CITY OF SAN ANTONIO

Re: Monticello Ranch Subdivision Amendment

MDP # 790A

MONTICELLO RANCH SUBDIVISION
 MASTER DEVELOPMENT PLAN #790A
 JANUARY 2005

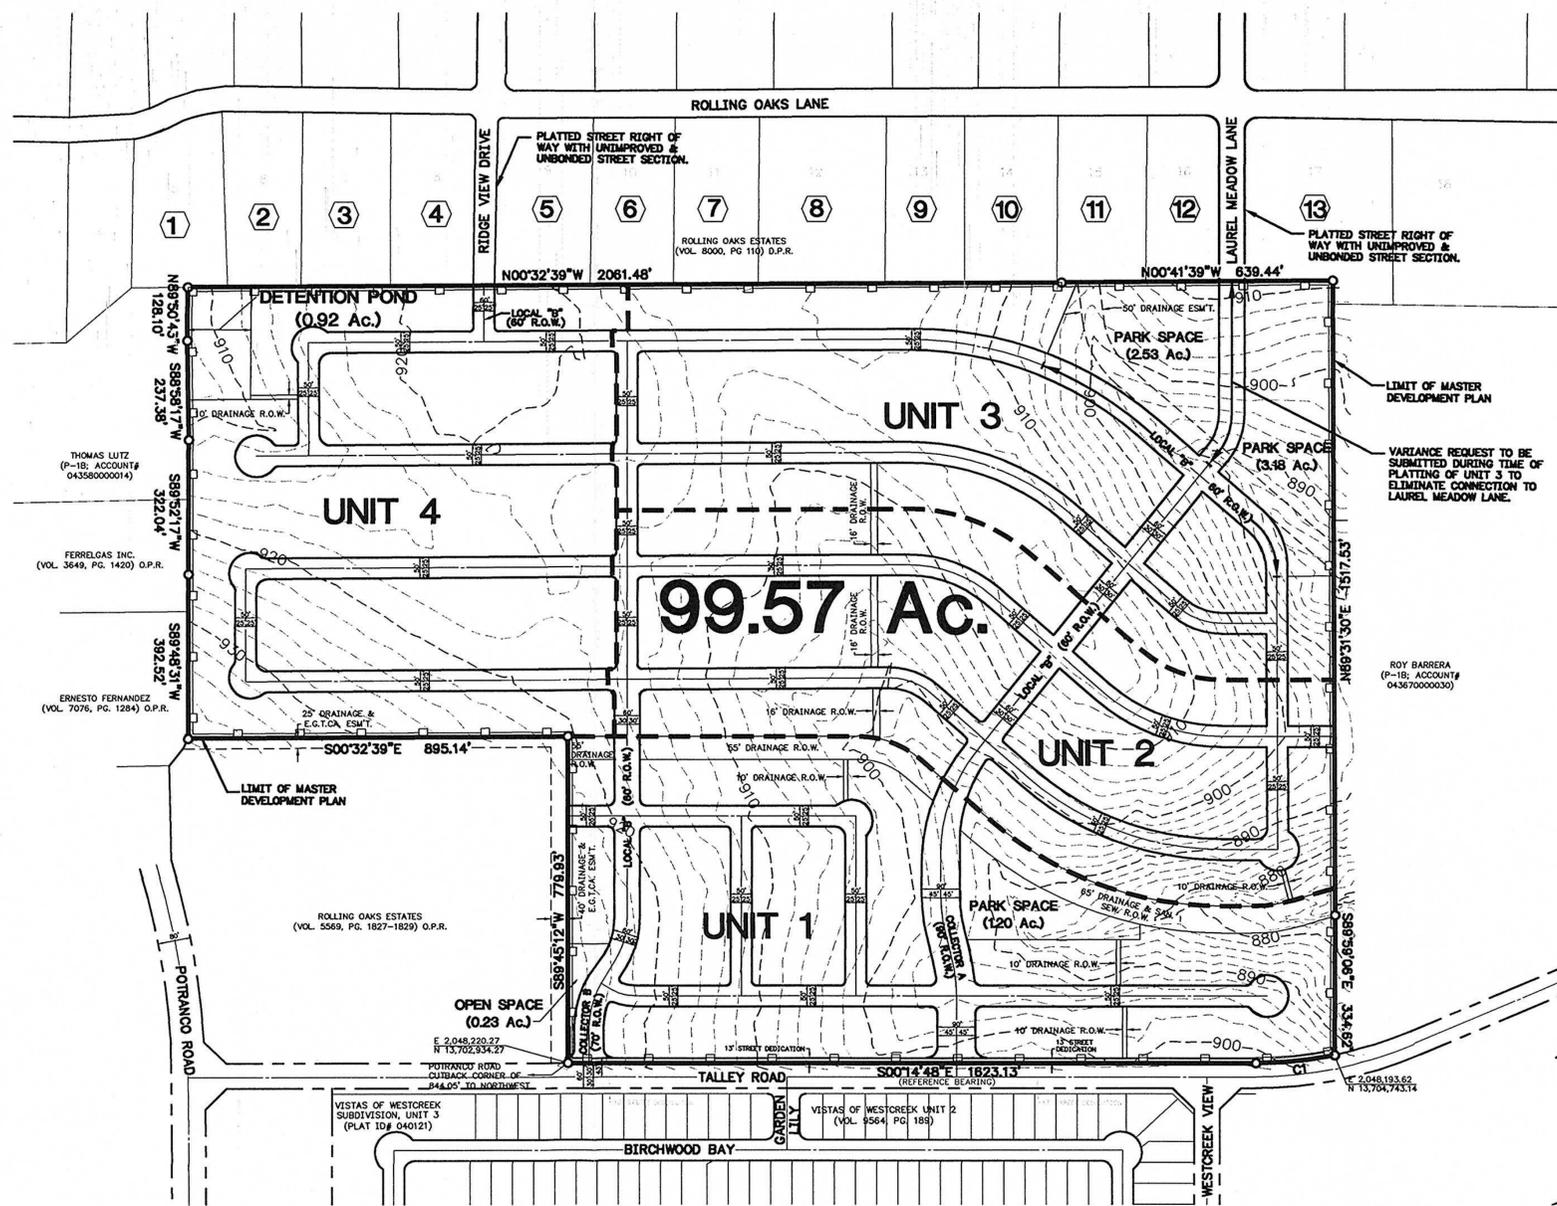
- a. Provide resolution for Street Link that exceeds block length standards in Unit 3.
- b. Provide transition length for change from Local B to Local A in Unit 2.
- c. Evaluate need for detention pond outfall easement.
